First, we would like to thank the referee for reviewing and commenting the manuscript. Please find the item-by-item reply below, with the original comments in *italics* and the responses in blue. The suggested changes will be implemented in the revised text.

The authors present a novel method of correcting slope-induced biases in radar satellite altimetry. A major challenge in assessing elevation and elevation changes of ice sheets. First, I have to applause the authors for revisiting this challenge, which has been a considerable error source in radar altimetry since the early work by (Brenner et al., 1983). Novel strategies for dealing with this issue are of interest to the radar community, but I will let it be up to the editor to decide if the topic is within the scope of "The Cryosphere".

Figure 1. Median (upper panels) and median absolute deviation (lower panels) with all points (both with and without outliers) included.

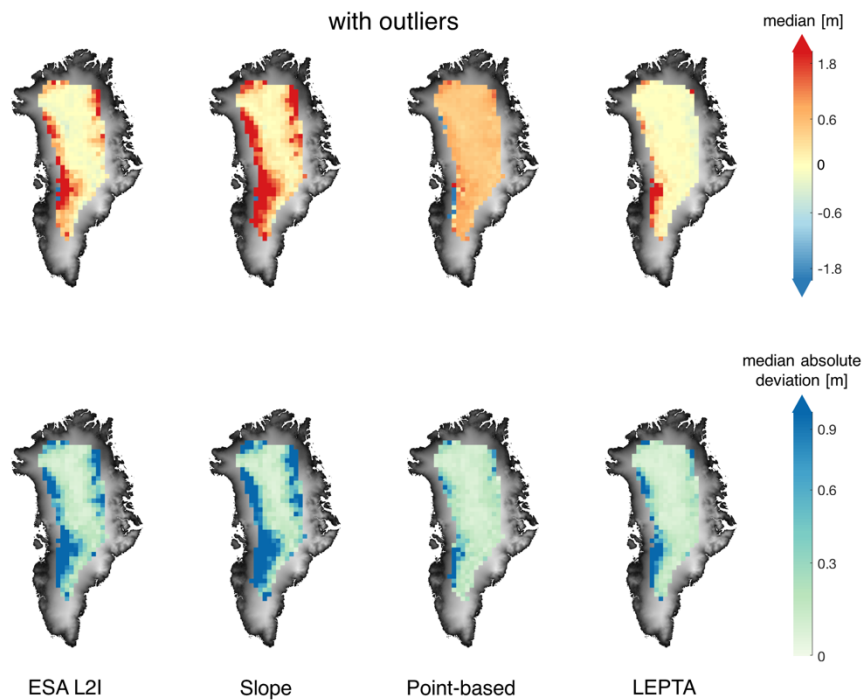
- How does the gridding of 50x50 km tiles influence the results? Why is the point-based method the only method missing data in the trunk of Jakobshavn isbrae? Why is there no data for all the methods east of the line from 79fjord to Helheim of figure 3? The data coverage seems different in figure 4.

The difference in data coverage between figures 3 and 4 originates from a minor issue in the plotting which will be solved in the revised manuscript. The fact that we lack data in the trunk of the Jakobshavn isbrae is caused by the fact that outliers are removed (please see attached figure).
